# Staff Report

## Infill Housing Design Review Committee

File Number: 5-C-24-IH

**Location:** 3436 Gap Road **Parcel ID** 81 I S 02802  
**Zoning:** RN-2 (Single-Family Residential Neighborhood)  
**District:** Lonsdale Infill Housing Overlay District

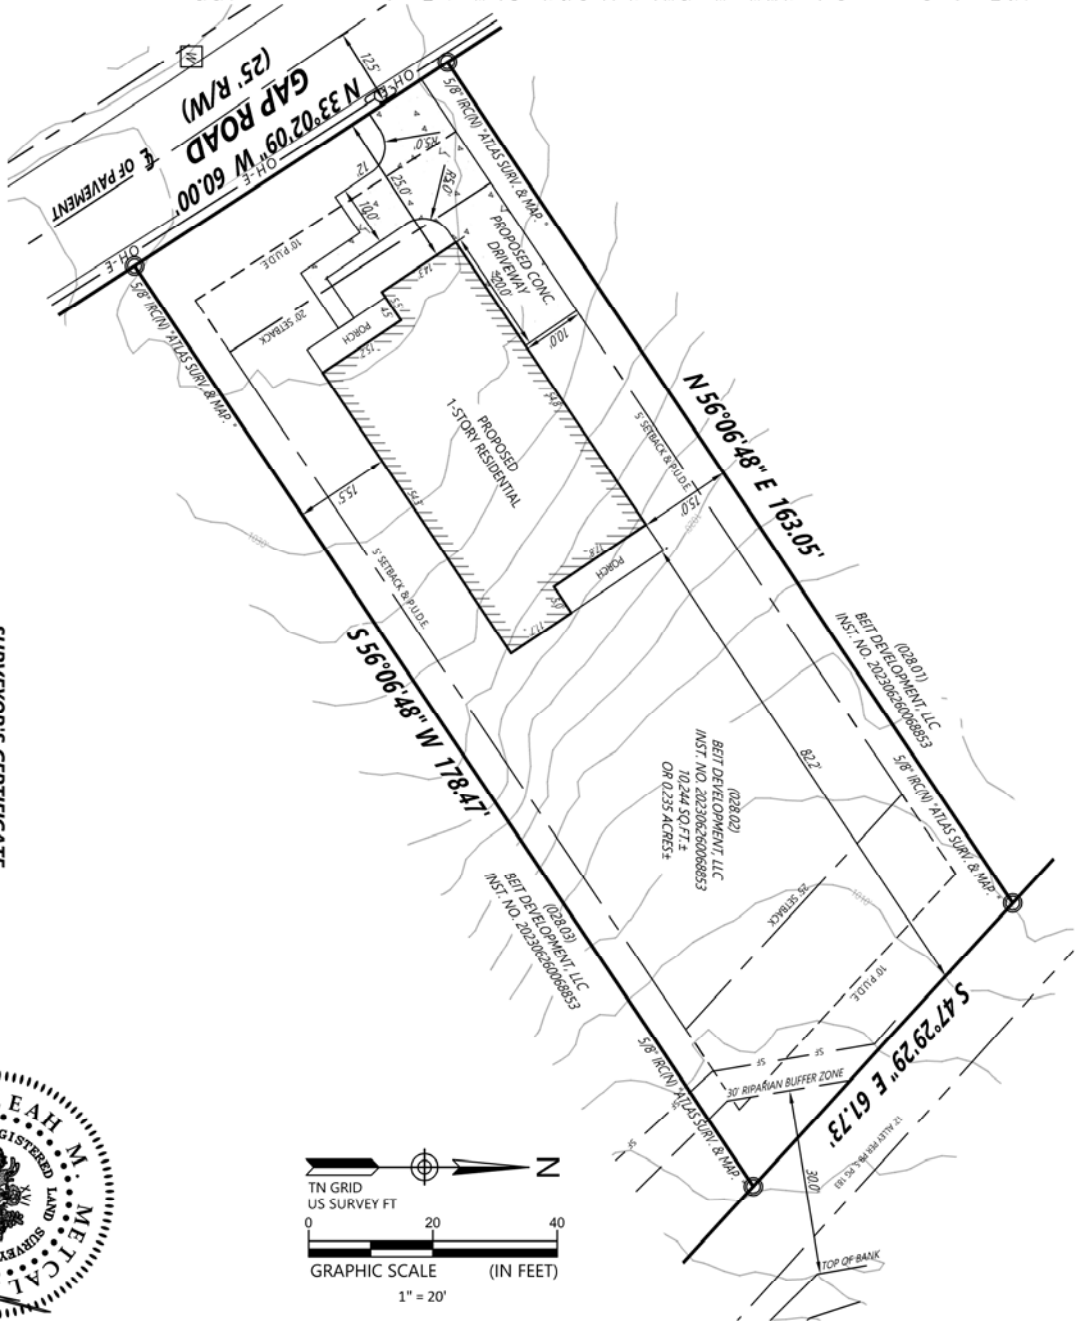
1. The house is proposed to be set 25' from the front property line. The block to receive new construction is relatively undeveloped; however, the existing houses on the block are set 15' and 18' from the front property line. The revised proposal has been aligned to align the four new houses on the block.

3. The application proposes a concrete driveway in the front of the house. Infill Housing guidelines recommend that on streets without alleys, parking areas should be at least 20' behind the front façade of the house with access limited to one lane between the street and the front façade. The turnaround may be required based on the site's topography and the conditions of Gap Road, but should be omitted if possible. Final site plans should meet City Engineering standards.

5. The revised application includes a 4'-5" deep entry stoop on the site plan and an 8' deep front porch on the floor plans. While an 8' deep porch meets the guidelines, the final site plan should include an accurate porch measurement.

9. Final site plans should include one native or naturalized shade tree in the front and rear yards. The lots currently feature a substantial amount of trees and other vegetation; existing trees should be retained if at all possible.

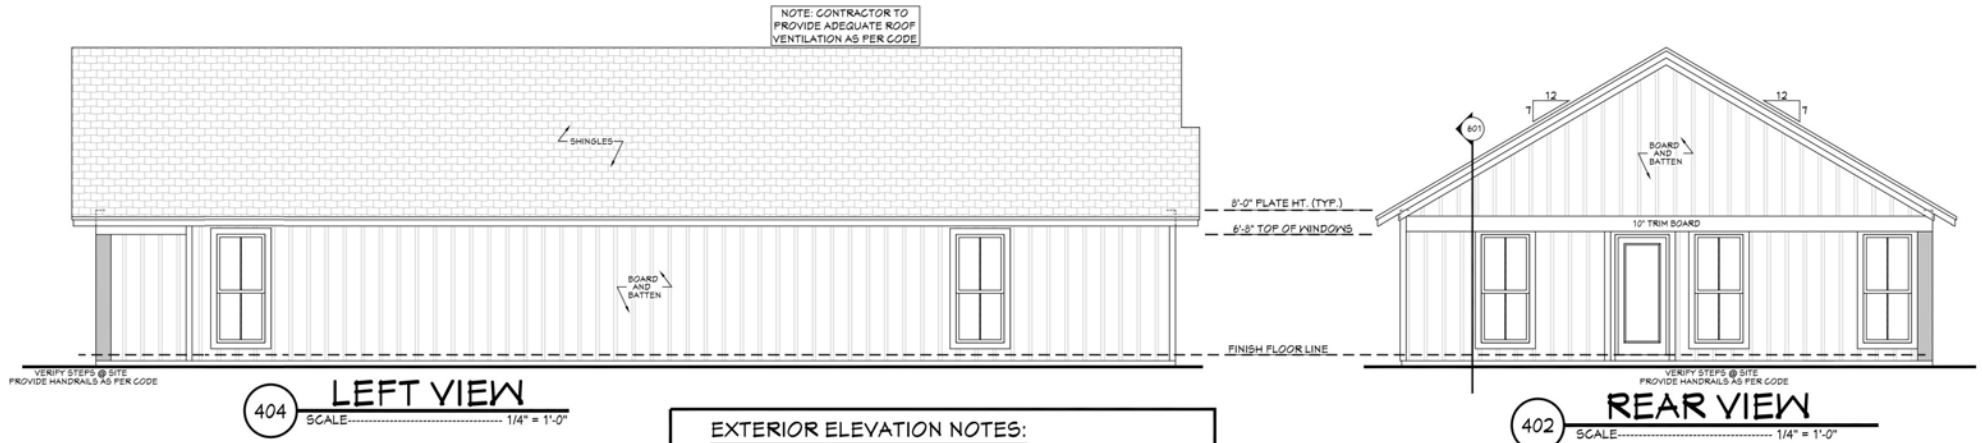
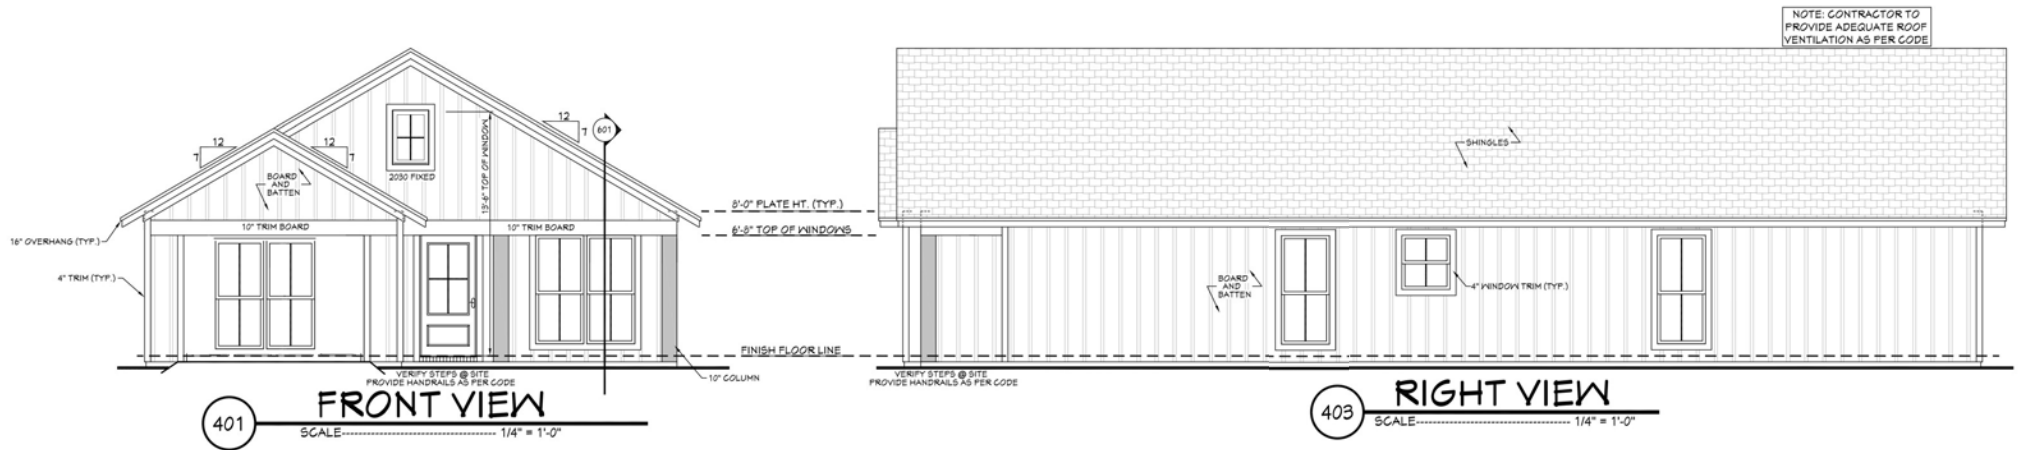
6. Guidelines recommend window and door styles be similar, with similar proportions and ratio of solid to void, to historic houses on the block and in the neighborhood. The revised application includes two windows on the left elevation and three on the right elevation.

7. The proposed roof pitch (7/12) meets the design guidelines.
8. The application does not include information on siding materials. Guidelines recommend that clapboard-like materials be used in new houses and discourages vertical siding; the houses should feature horizontal lap siding instead of board-and-batten. Final drawings should accurately show the siding to be installed.

Siding will be horizontal lap siding

# FLOOR PLAN

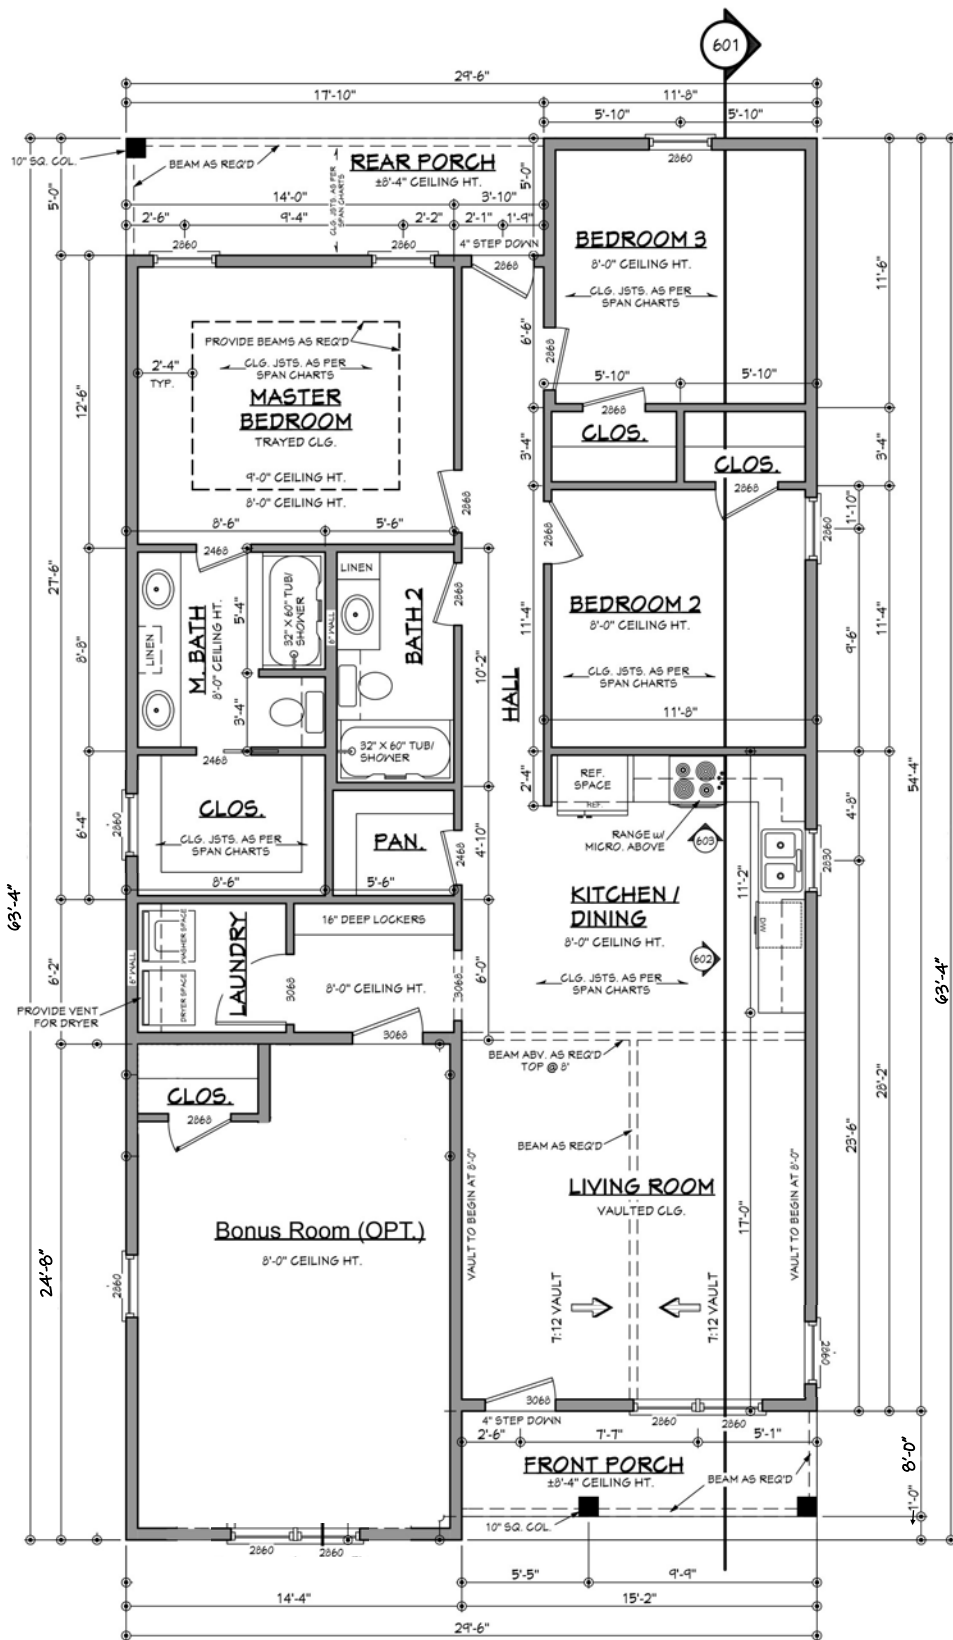
4) revised front porch design to measure at least 8 feet deep;

Revised plan emailed in separately to Lindsay Crockett

201 FOUNDATION PLAN  
SCALE: 1/4" = 1'-0"

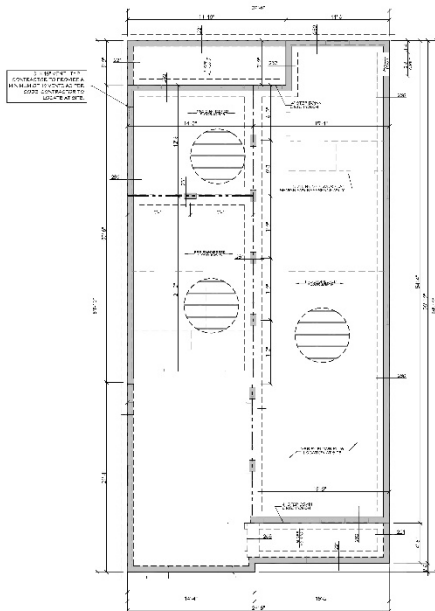
3) foundation to be elevated at least 12 inches to reflect historic houses in the neighborhood, with a revised foundation profile submitted to staff;

Foundation plan (below) does not specify a total height. Crawl space will exceed the 12 inch requirement
